PREVOST

WARRANTY BULLETIN

WB24-32

DATE :	September 2024	SECTION :	23 ACCESSORIES
EXPIRATION:	September 2026		
SUBJECT :	OUTSIDE MIRROR HEAT SWITCH - WIRING MODIFICATION

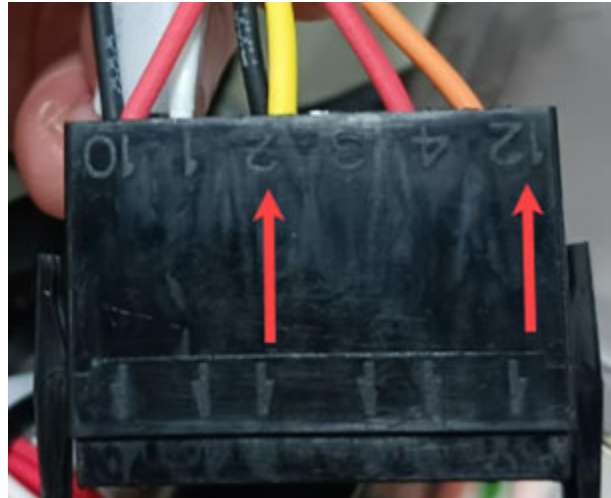
8. Extract the terminals from pins 2 and 12 of the connector. These wires should be swapped.
9. Insert the terminal of wire **A45J1.16** in the **pin 2** of the connector.
10. Insert the terminal of wire **A49J1.1** in the **pin 12** of the connector.
